Project #20-062
Blue Springs Flex Buildings
Located at approximately 150 S. 100 E.

Project Name: Blue Springs Business Park
Proponent / Owner: Gus Pacheco / Blue Spring Business Park LLC
Project Address: Approx. 600-800 West 1000 North
Request: Design Review & Subdivision Permit
Current Zoning: Industrial Park (IP)
Type of Action: Quasi-Judicial
Hearing Date: Aug. 13, 2020
Submitted By: Russ Holley, Senior Planner

RECOMMENDATION

Figure 2 shows the proposed site plan with the outdoor storage areas in between.

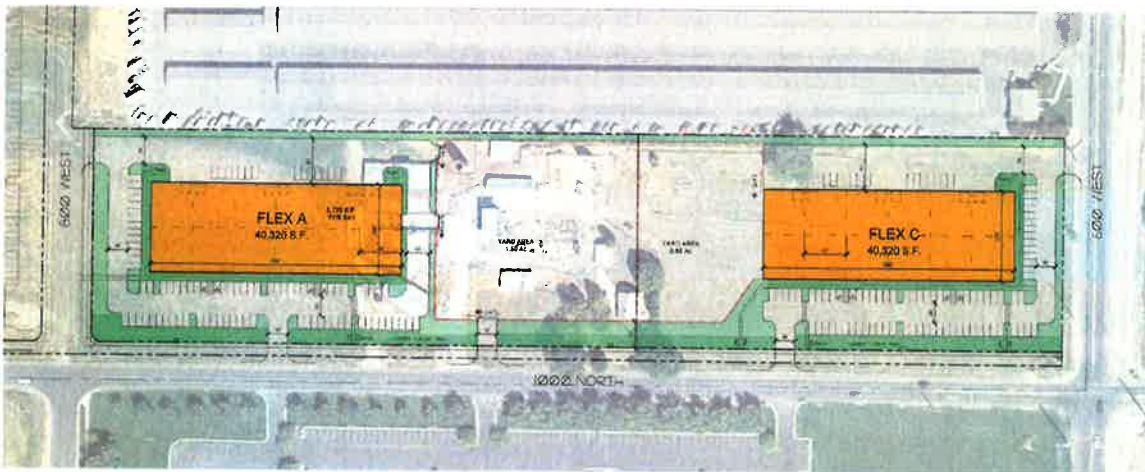
The following setbacks are proposed for the buildings (as measured from the exterior property lines of the project site, at closest points):

Front (south):	92'
Corner (east/west):	62'
Side (interior):	8'
Rear (north):	68'
Parking (front):	20'

As conditioned with 20' side yard setbacks, the project meets the requirements for the zone.

6. The side setbacks shall be 20 feet or more between the building and the property line.
7. The outdoor storage areas shall be screened with a six (6) foot tall solid fence and have landscaping placed in front in a Type "B" design as per LDC 17.32.070.

SOUTH SIDE BUILDING ELEVATION
FACING STREET FACADE - 11,000 SF
GLAZING - 3,300 SF
GLAZING / STREET FACADE - 30%

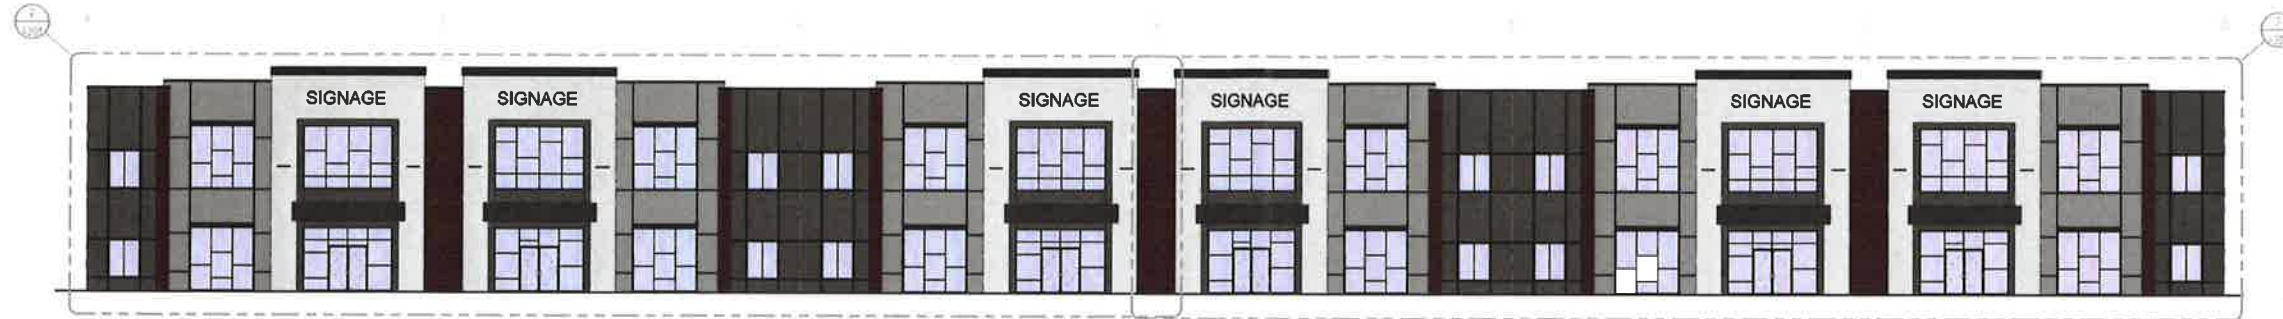
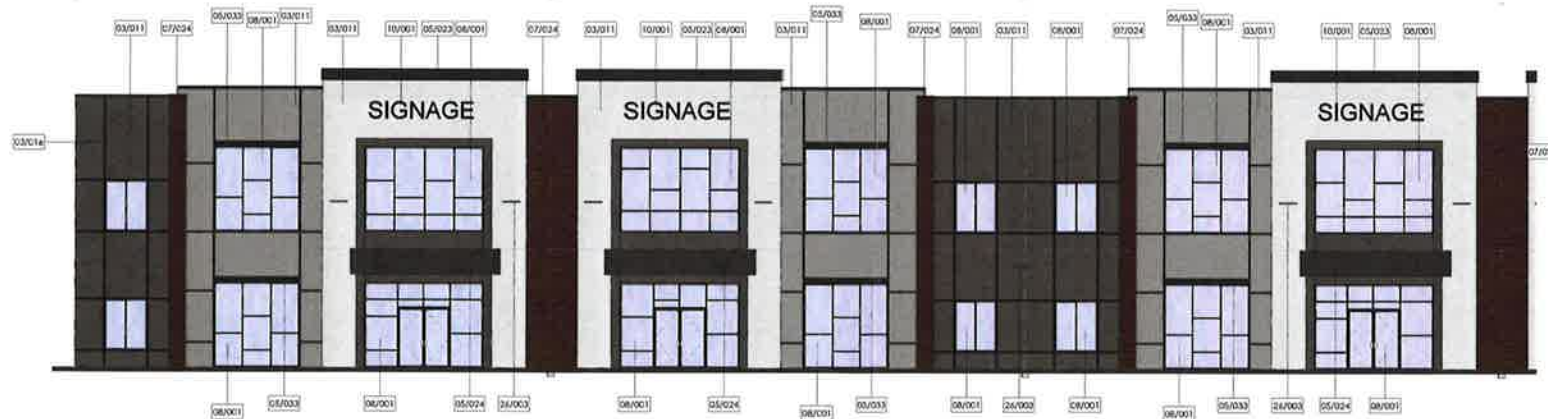
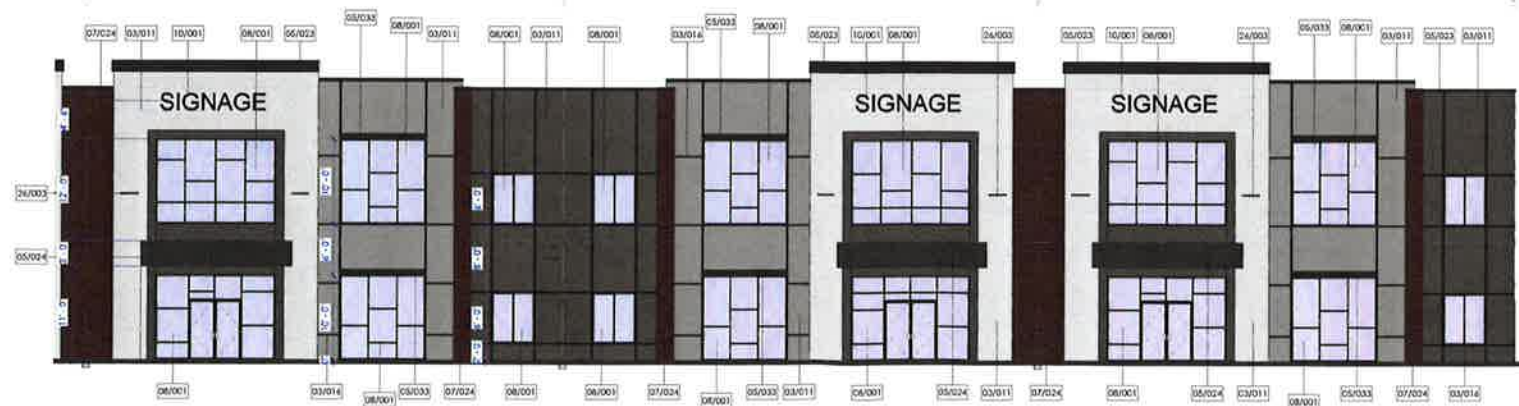
materials proposed are multiple textured concrete sections, composite wood-like materials and metal trim and accents. The ground floor areas along the south façades fronting 1000 North are shown with 30% transparency. The two corner facades facing 600 West and 800 West are shown with approximately 2% transparency and blank sections exceeding 40 feet. The two buildings show identical front façade designs, however; the overall master plan shows a future building placed between these two buildings. If that future building has a different front façade design, then code compliance can be achieved. As conditioned with additional transparency and wall breaks along the corner street-facing façades and the Planning Commission determining the temporary identical façade design issue, the building design meets the requirements in the LDC.

5. The corner street facing elevations adjacent to 800 West and 600 West shall add architectural features similar to the south façade and at least 27% transparency.
